File 1977-0028

Project Name: Pheasant Run at Spring Valley

Subdivision Pleasant Run at Spring Valley
 Date 4/6/77 Item # 28-77
 Petitioner Discovery "76"

Subdivision Pheasant Run at Spring Valley
 Date 1 Nov 77 Item # 28-77
 Petitioner Paul S. Barru et al

PHEASANT RUN SPRING VALLEY - FILING NO. FIVE

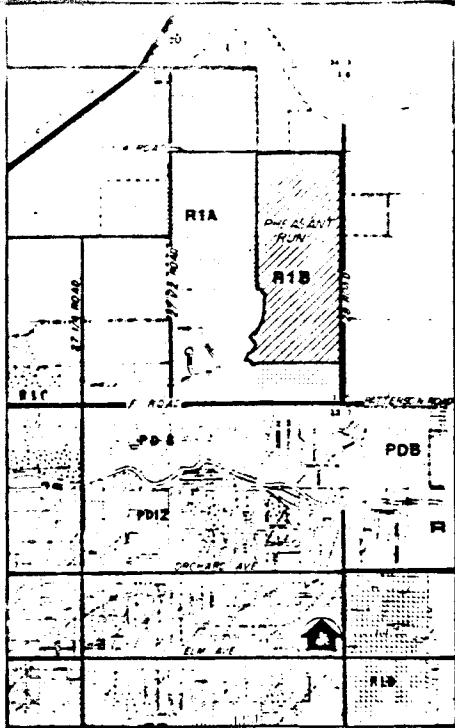
P.S. - additional easements
 required.
 mtn Bell - 10' easement
 required around irrigation
 pond.
 Dev. To stock irrigation
 pond annually if necessary
 w. Gambuzi Fish

Approved 28' matt parking
one side for Pheasant
Run Circle.

- (a) 14' utility drainage & irrigation easement located between lots 7 & 8, Block 10.
- (b) Drainage easement added to Lots 14, 15, 16 and along 28 Road.
- (c) 40' Utility, drainage and irrigation easement at South boundary of Filing for drain ditch.
- (d) The words "Private Ownership" has been removed from irrigation pond.
